CALL NO. 200
CONTRACT ID NO. 111024
ADDENDUM # 2

Subject: Christian County, 024GR11D024-IM & JL03
Letting May 20, 2011

(1) Revised - Plan Sheets - R2, R2A, R2B, R2C, R2D, R2F, & R2H

I-24 / US 41A INTERCHANGE I-24 TYPICAL SECTIONS

COUNTY OF	ITEM NO.	SHEET NO.
CHRISTIAN	2-213.00	R2c

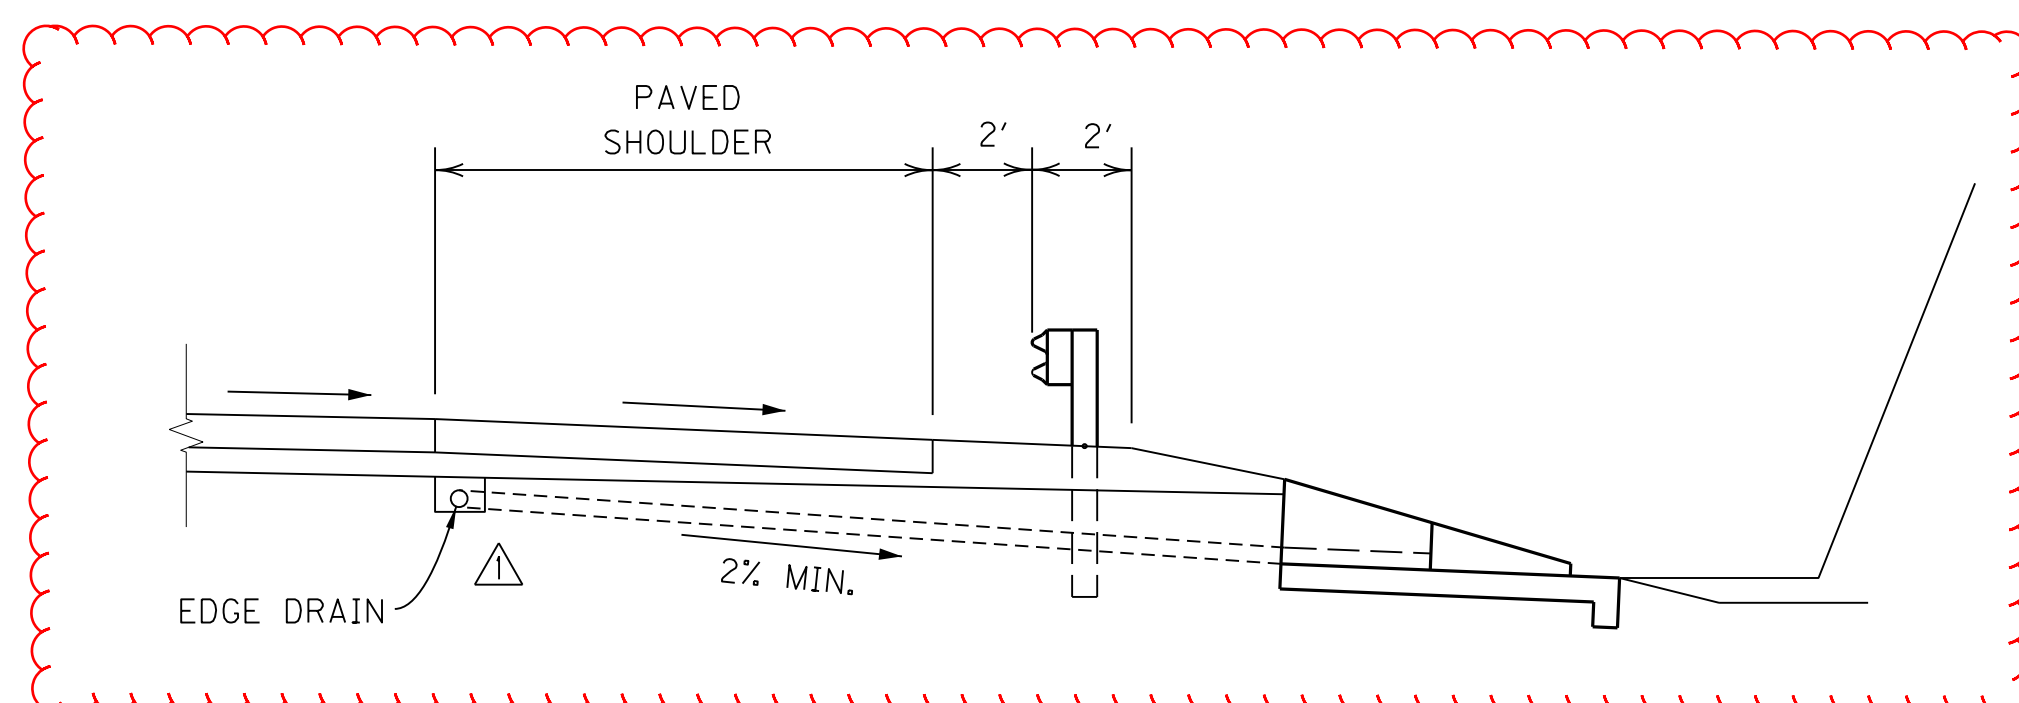
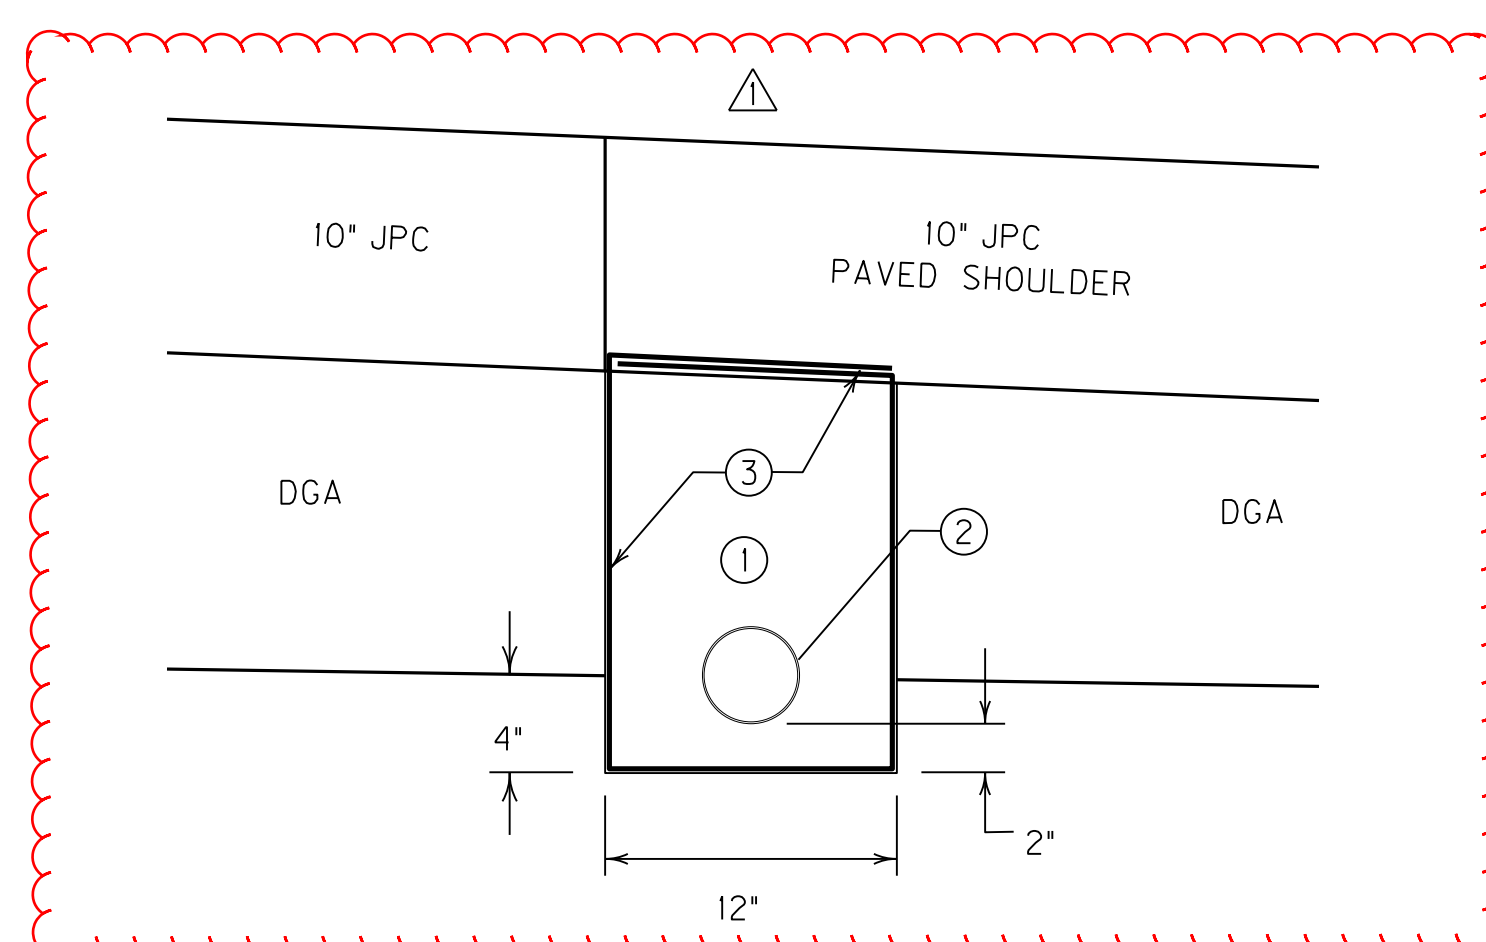
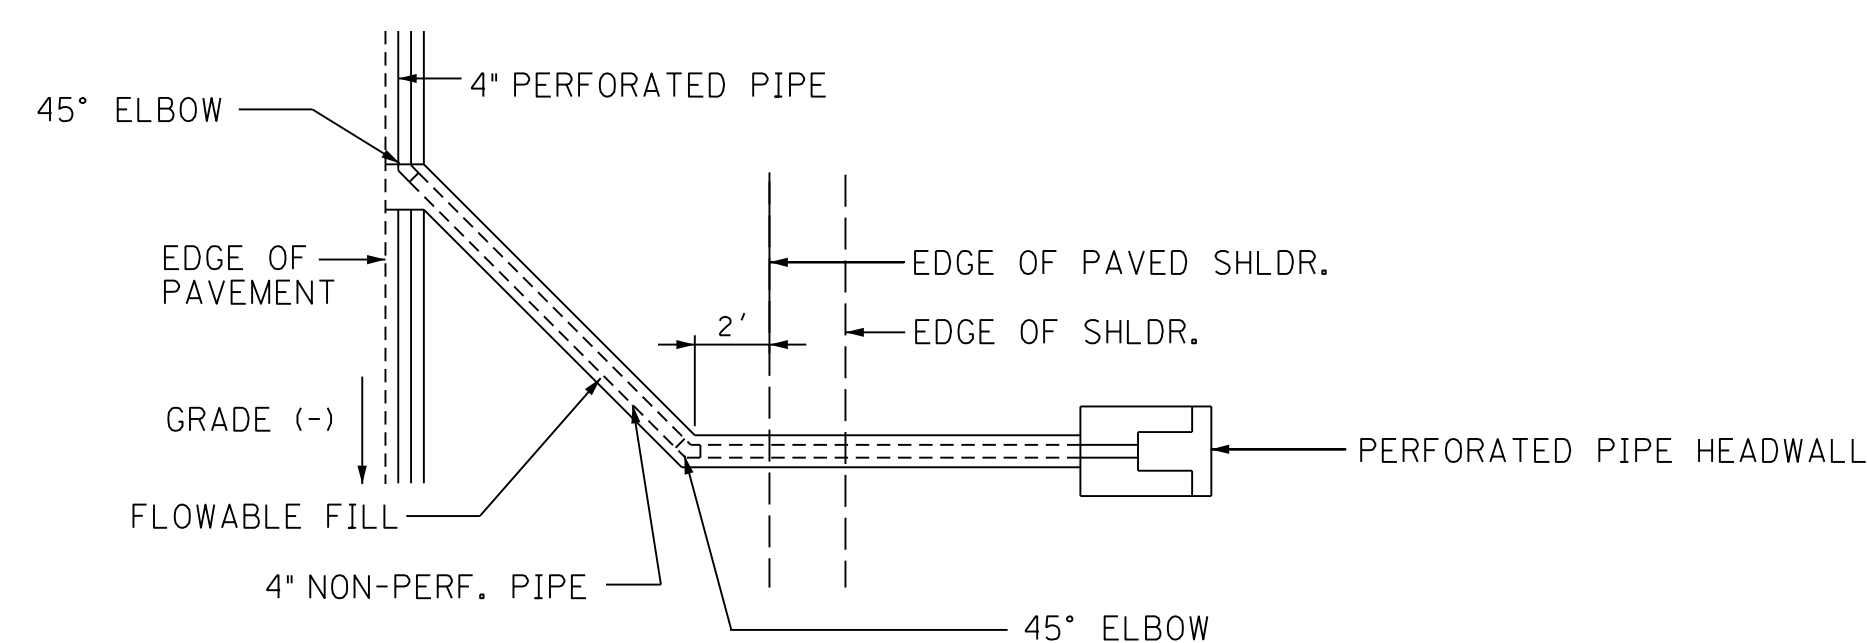
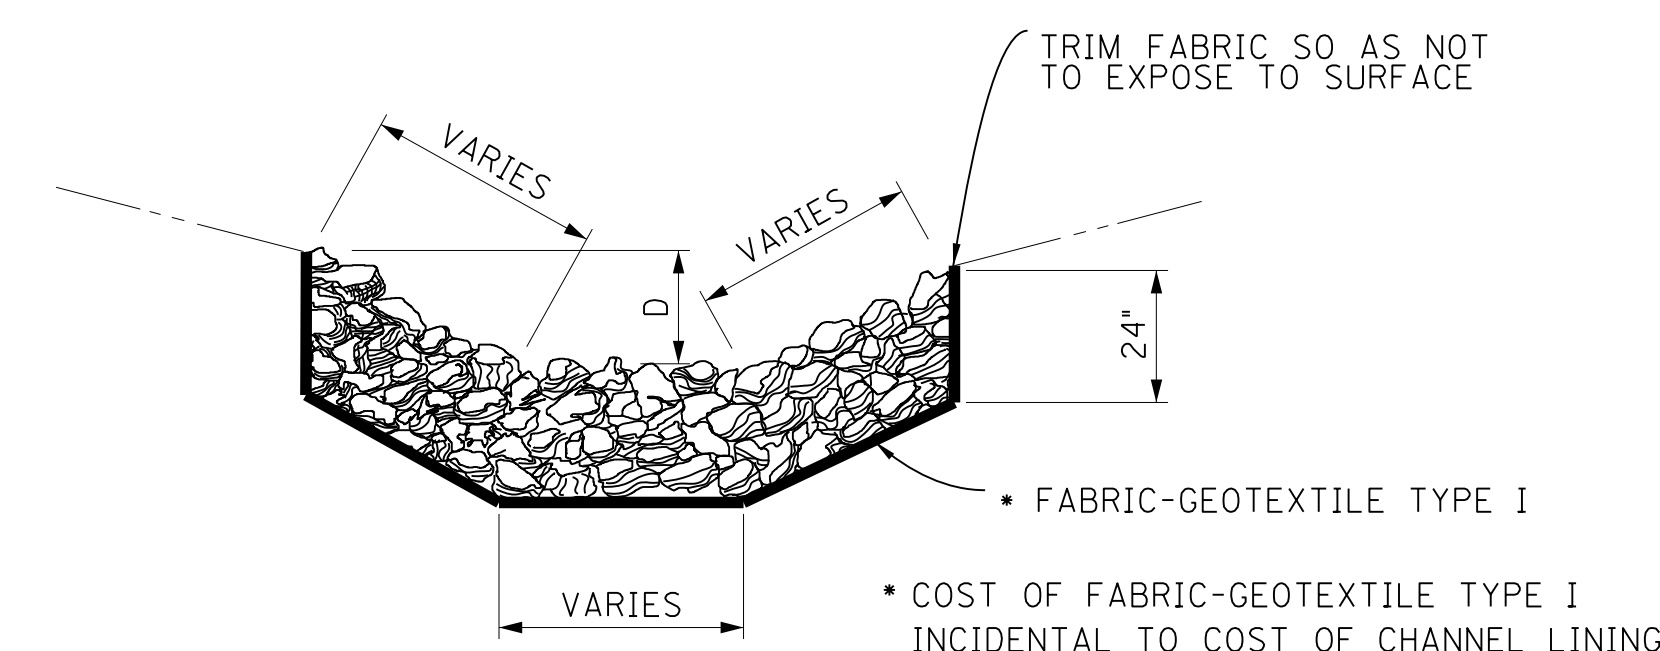
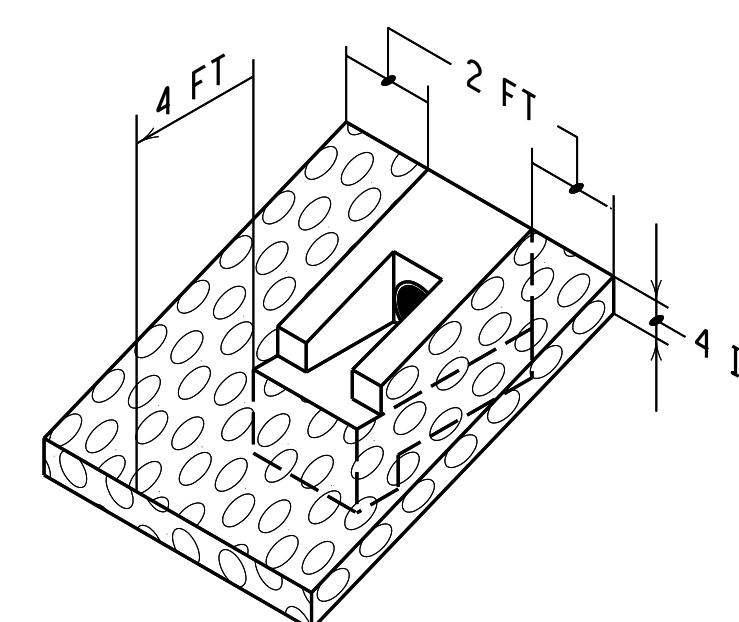
△ REVISED 5-3-11
